CITY OF VANCOUVER
COMMUNITY SERVICES GROUP

DEVELOPMENT PERMIT STAFF COMMITTEE REPORT
AUGUST 13, 2014

1710 EAST BROADWAY
DE418037 - ZONE C-3A / CD-1

- **Proposal:** Interior and exterior alterations to the existing Transit Station, work includes the upgrading the pedestrian connections by creating new platforms and a passerelle (pedestrian bridge) over Broadway Street and upgrading of the ticket hall entrance, a bike storage facility and provisions for a future retail areas.

1 PASSERELLE LEVEL OVERALL PLAN

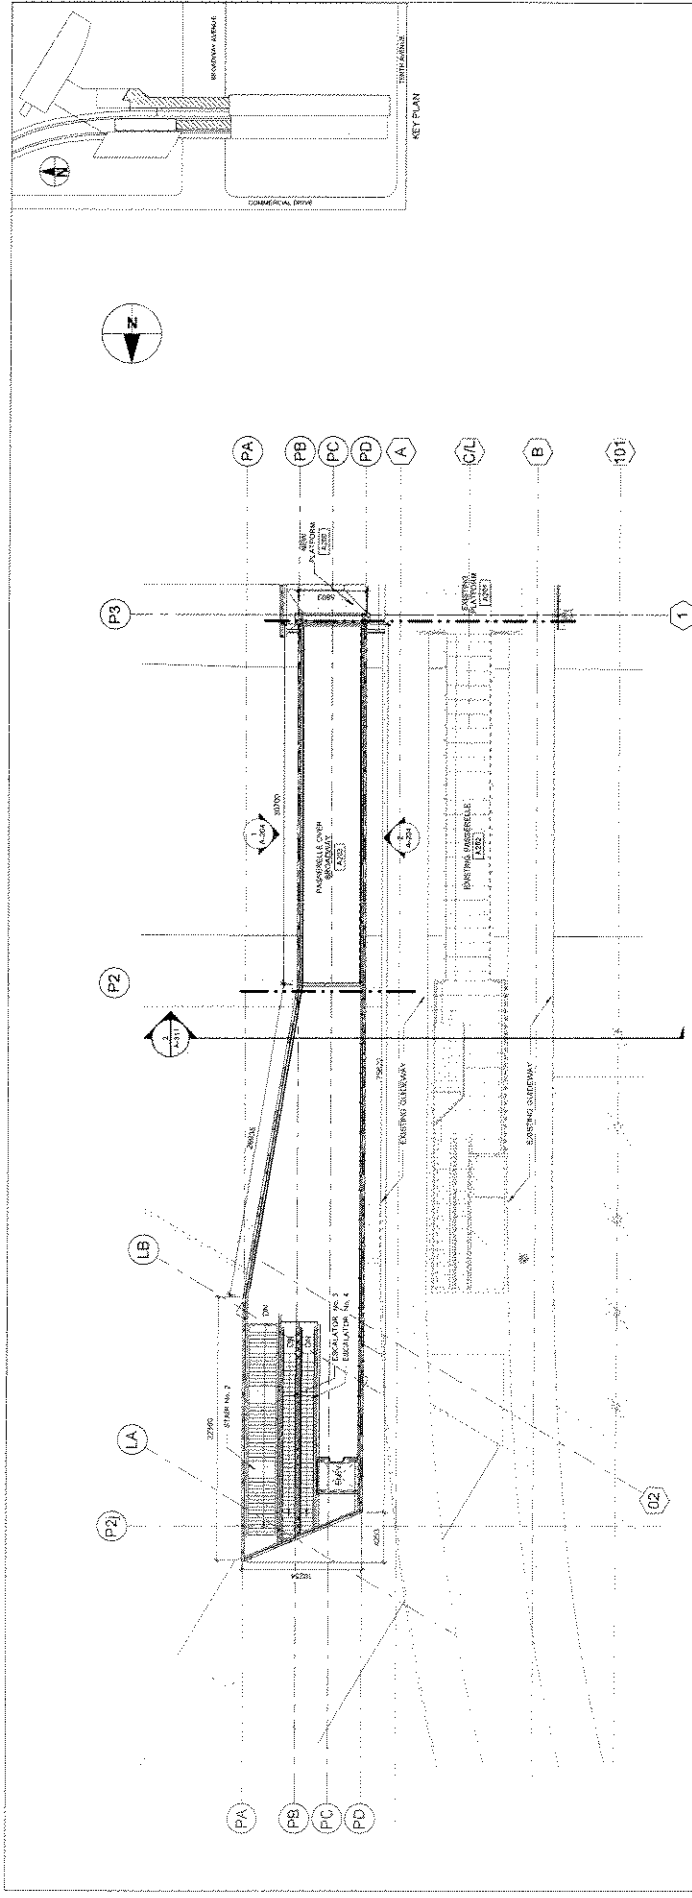
The column supporting the passerelle along the Broadway frontage has been shaped to minimize its impact to the pedestrian movement and transit bus queuing that occurs along this frontage. Further detailed information is requested to ensure that the Broadway B-line queuing and shelter design will be appropriate integrated along this frontage. Terms to secure the adjacent sidewalk width will be required. (see Recommended Condition 1.9)

- Consider increasing the width of the passerelle;
 - Design development to better announce the entries;
 - Design development to improve the termination of the station ends;

Regarding sustainability, the Panel noted that there aren't any sustainability features expressed in the proposal. There were some concerns regarding how the passerelle would be ventilated being that it would get hot since it is mostly a glass box. As well they wanted to see some shading devices on all the glass.

1 MAIN TICKET HALL OVERALL FLOOR PLAN

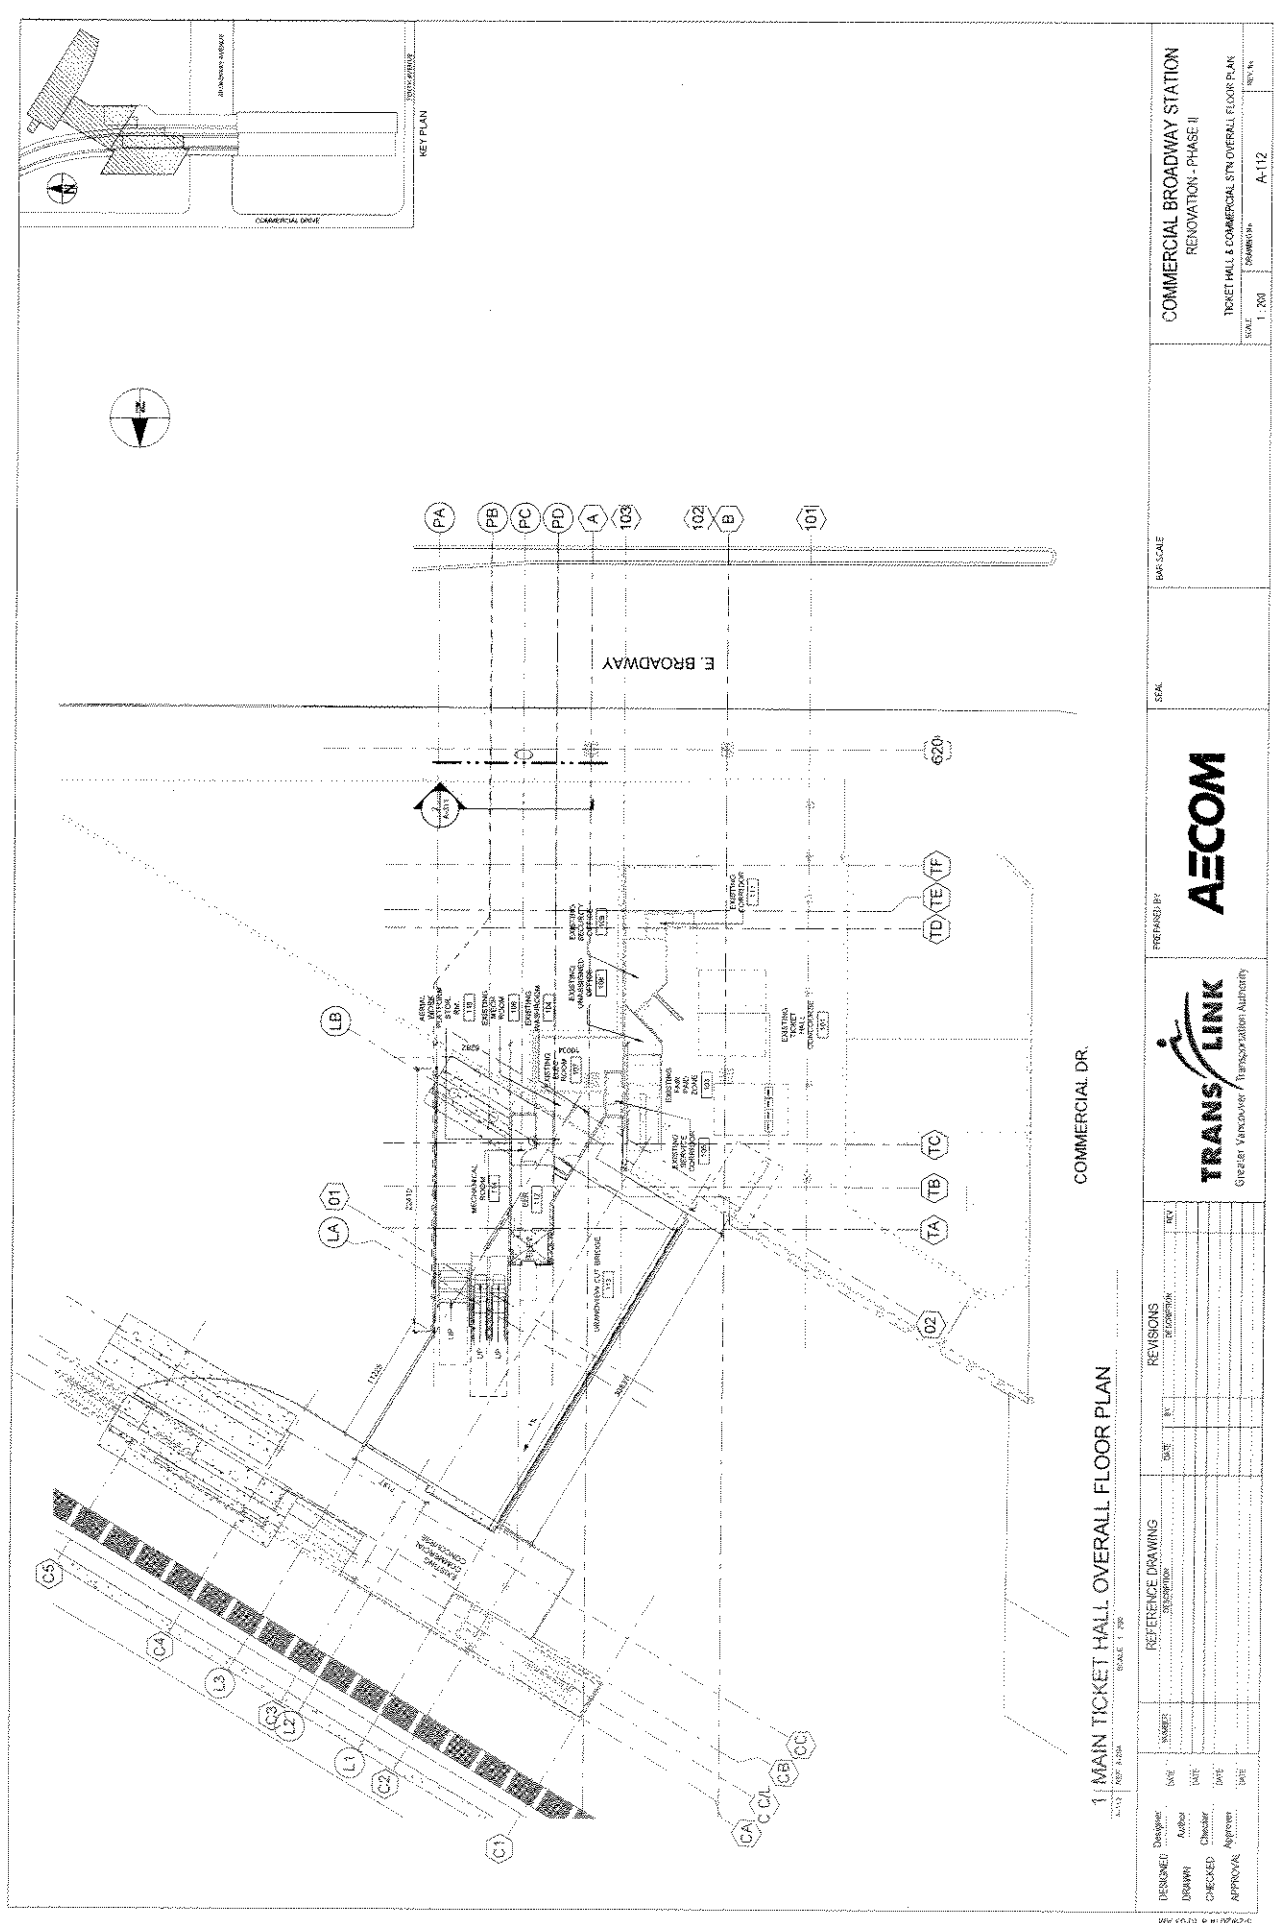
- 1.12 consideration of modifications to improve pedestrian circulation by the following:
- a) relocation of the placement of the west fare gates at the north entrance of the south station to align these with new east fare gates to provide additional circulation space in front of escalators across the width of the station;

- b) removal of the proposed retail space immediately south of the ticket alcove to ensure adequate pedestrian circulation
- 2.0 That the conditions set out in Appendix A be met prior to the issuance of the Development Permit.
